<p>CARNEGIE FORUM 305 WEST PINE STREET LODI, CALIFORNIA</p>	<p>AGENDA LODI SITE PLAN & ARCHITECTURAL REVIEW COMMITTEE</p>	<p>REGULAR SESSION WEDNESDAY, APRIL 27, 2016 @ 5:15 PM</p>
---	--	--

CITY OF LODI
SITE PLAN AND ARCHITECTURAL REVIEW COMMITTEE
Staff Report

REQUEST: Request of Site Plan and Architecture Review Committee (SPARC) to consider Site Plan and Architectural Review of the Reynolds Ranch Multi-family project (Rubicon at Reynolds Ranch) containing 156 residential units – 2951 Reynolds Ranch Parkway. (Applicant: Skinner Ranch Holdings; File Number: 2016-09 SP; CEQA Determination: Exempt Per Section 15153)

REQUEST: Request of Site Plan and Architecture Review Committee (SPARC) to consider Site Plan and Architectural Review of the Lodi Auto Lounge – 1200 Pixley Parkway. (Applicant: Mike Singh; File Number: 2016-10 SP; CEQA Determination: Exempt Per Section 15332)

SITE PLAN

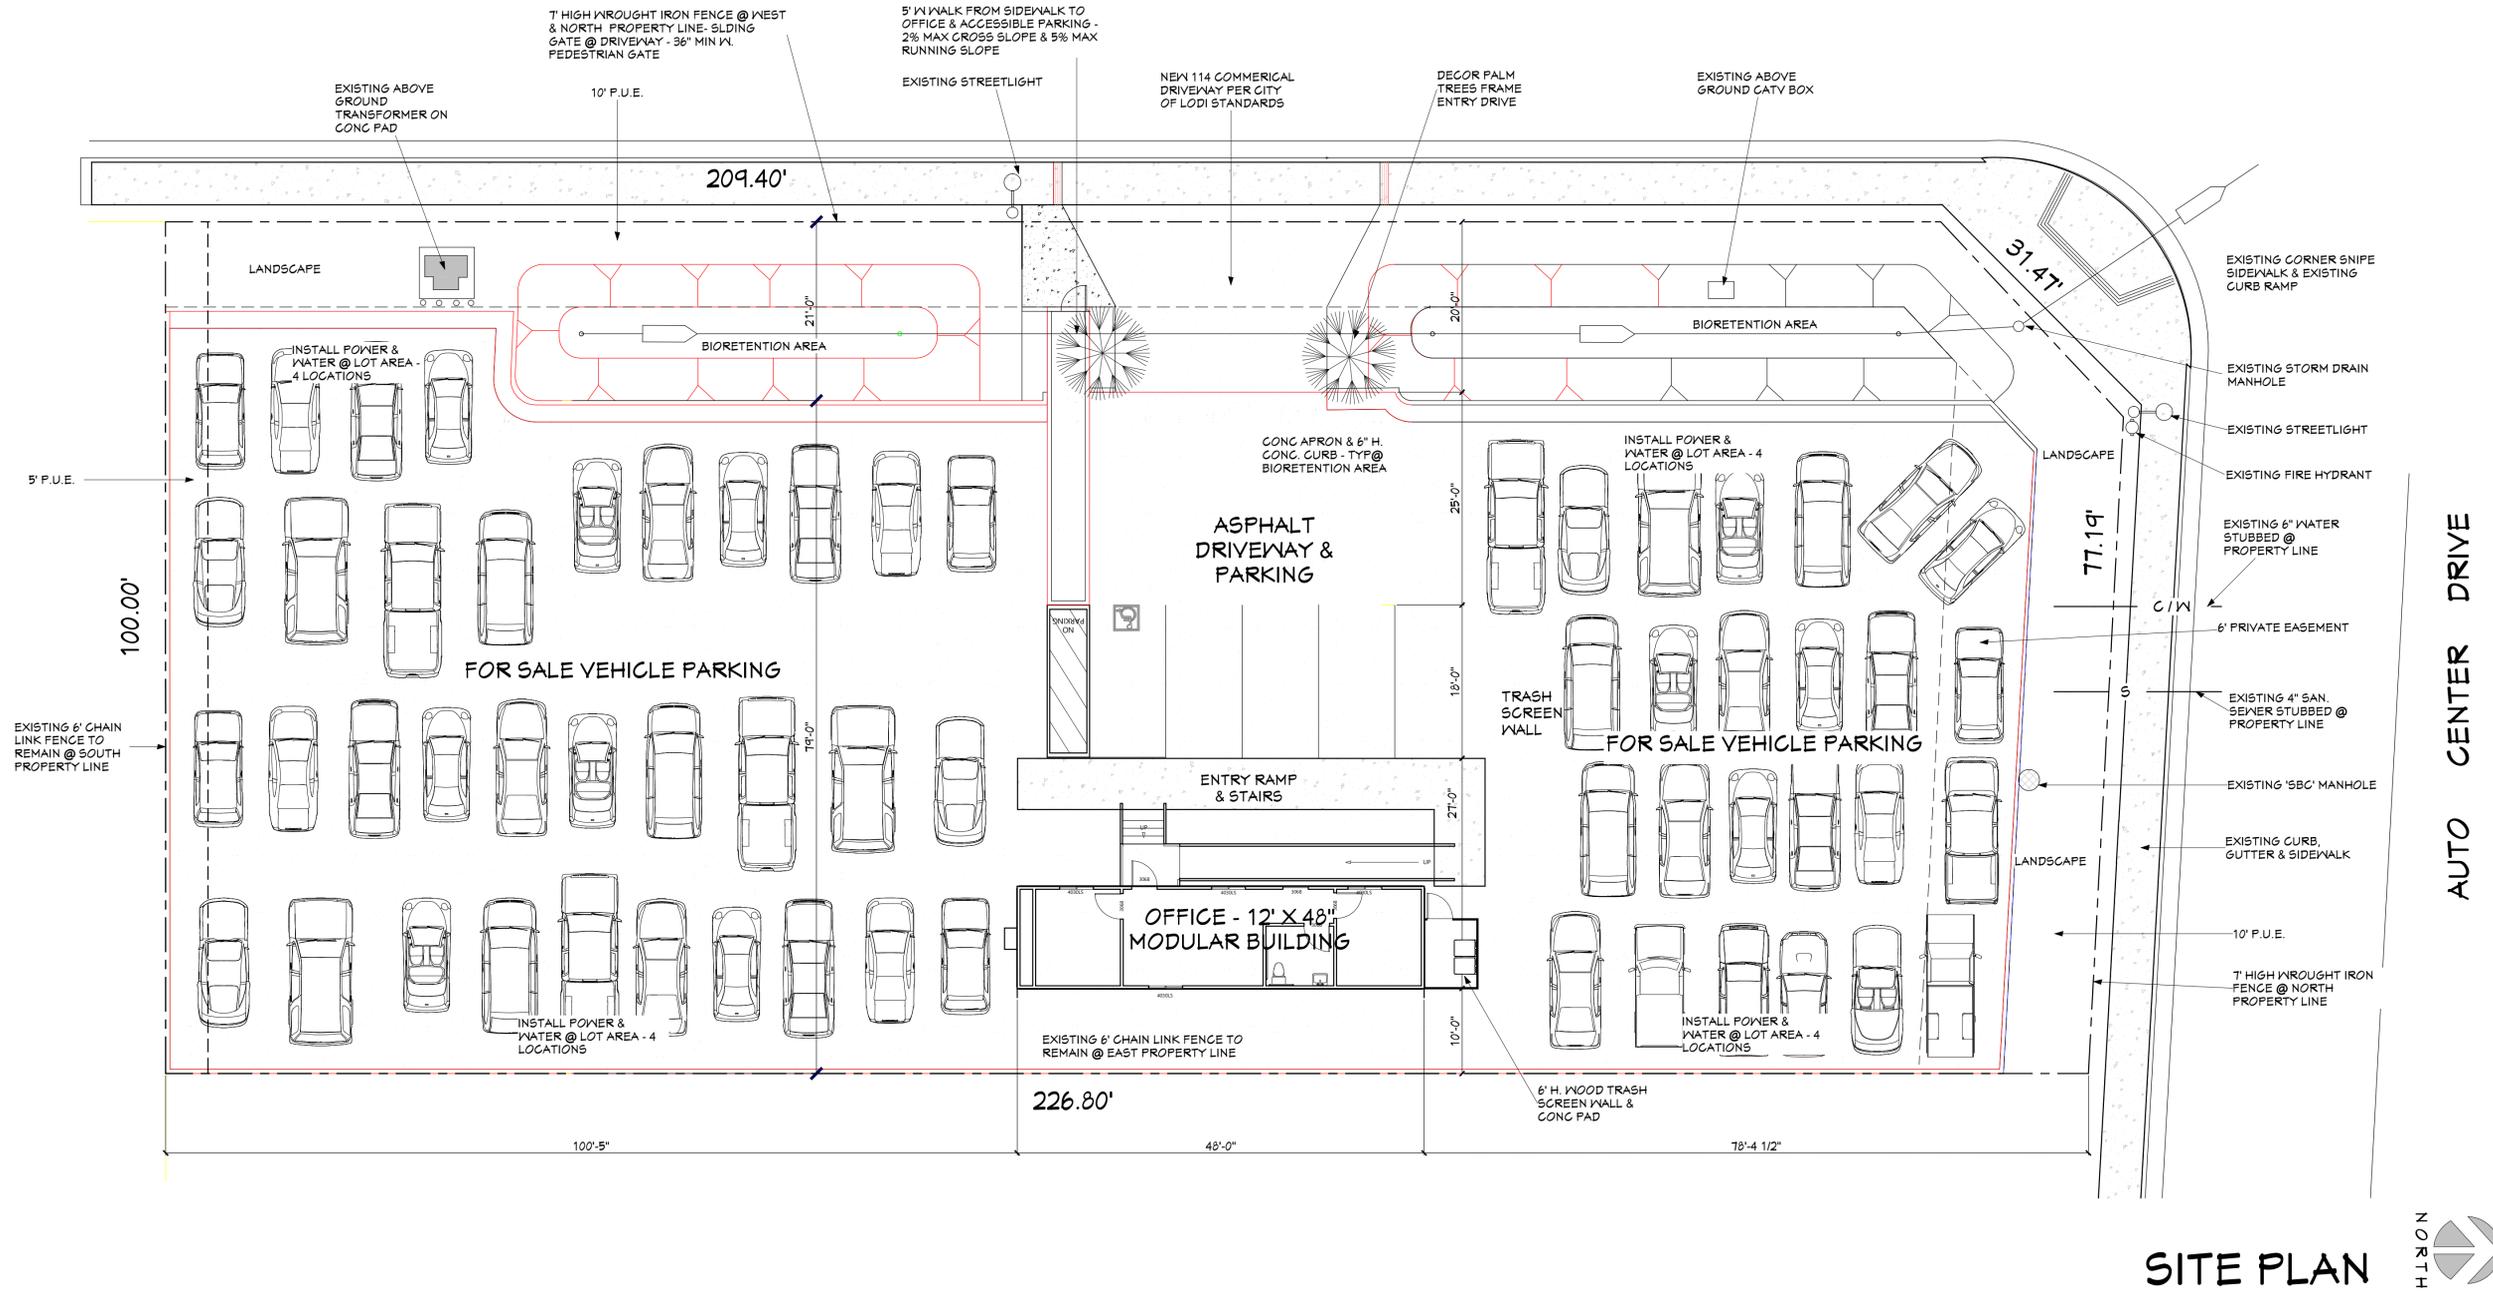
8. No flashing, moving, animated, temporary signs or banners shall be permitted.
9. The wrought iron fence will be set back 10 feet from the sidewalk, out of the PUE.
A final landscape plan will be submitted consistent with landscaping on the southern property (DMV).

10. Install ADA compliant driveway on Pixely Parkway as per City of Lodi Standard Plan 114.
11. There is an existing 10-foot Public Utility Easement along Pixely Parkway. The proposed bioswale may not encroach within the Public Utility Easement.

20. Site Plan to show all building entrances and ground level exits shall be connected on an accessible route to accessible parking/passenger loading zones and to public streets and sidewalks. 2013 CBC, Sections 11B-206.1, 11B-206.2.1, 11B-206.2.2, 11B-206.2.4, 11B-206.4, 11B206.4.1.1, 11B-Division 4

- C. Specify pavement-marking symbols at each accessible parking space. 2013 CBC, Section 11B-502.6.4
25. The plans shall specify and show a fire access lane to extend within 150' of all portions of the new building. The fire access lane is to be a minimum of 24' wide. Dead end fire access lanes in excess of 150' in length shall be provided with an approved area for turning around fire apparatus. Further, the plans shall specify and show fire lane striping (red curb or stripe with "Fire Lane" in white letters, 3/4" stroke at intervals not less than 50') and fire lane sign at the entrance and the extremity of the lane. 2013 CFC, Section 503.1 and LMC 15.20.080

MODULAR OFFICE FLOOR PLAN

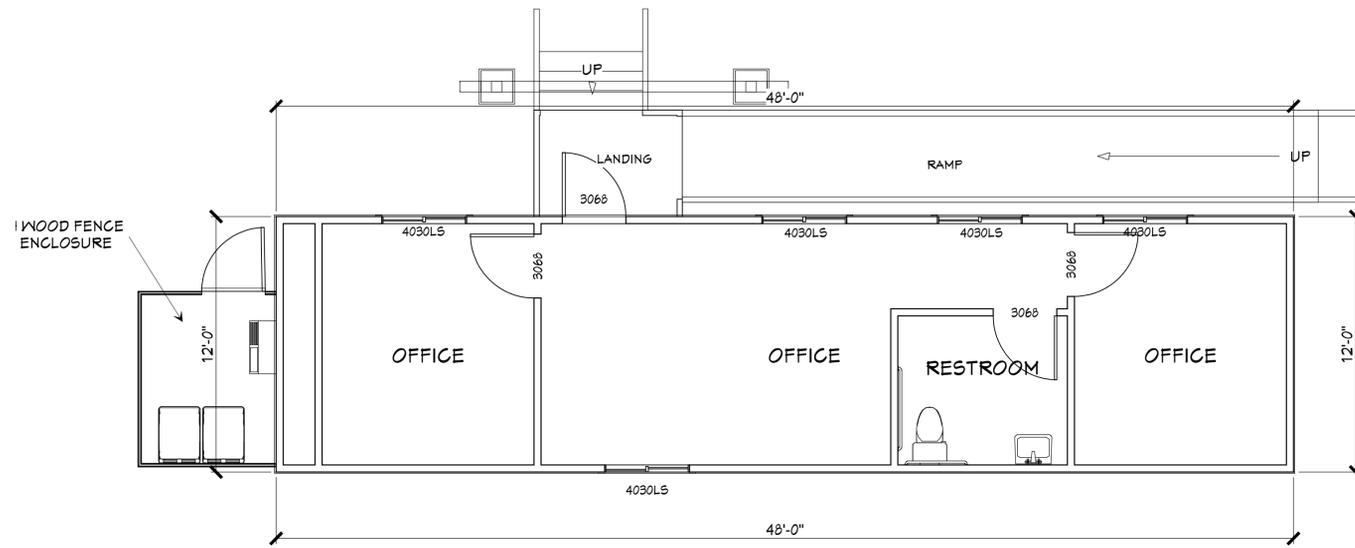
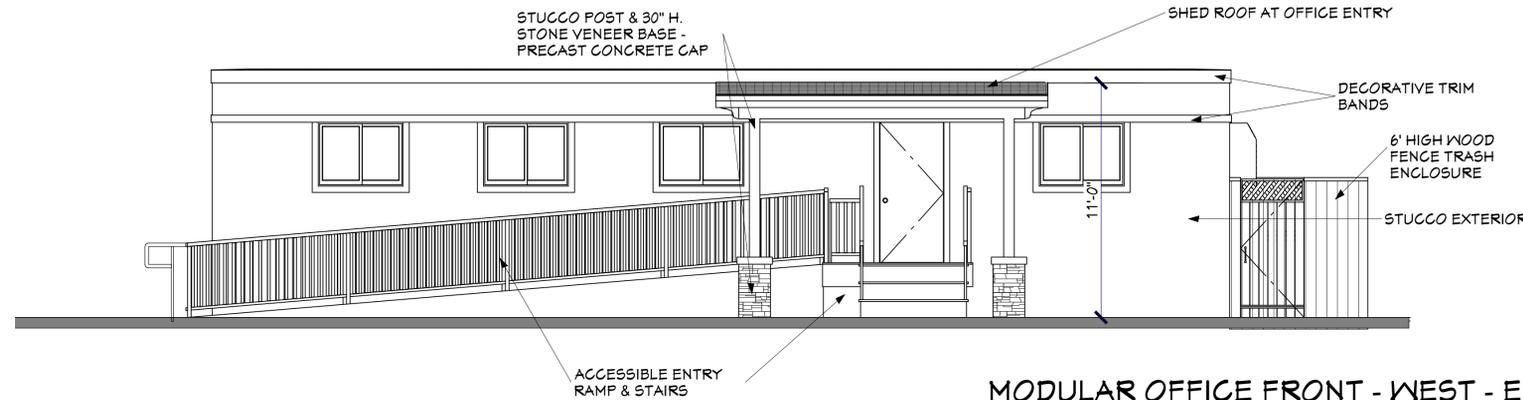
17. Separate building permits will be required for a) the modular building including footings/hold downs and utility connections, b) the site work including the ramp/stairs, accessible path of travel and fence gates c) awning if it is not attached to the modular building. All plan submittals shall be based on the City of Lodi Building Regulations and currently adopted 2013 California Building code. Please review our policy handouts for specific submittal procedures.

21. Plans will provide complete and adequate details of the pedestrian ramp, from modular building doors to pavement, including but not limited to all required landings, handrails with extensions, etc. 2013 CBC, Sections 11B-404, 11B-505
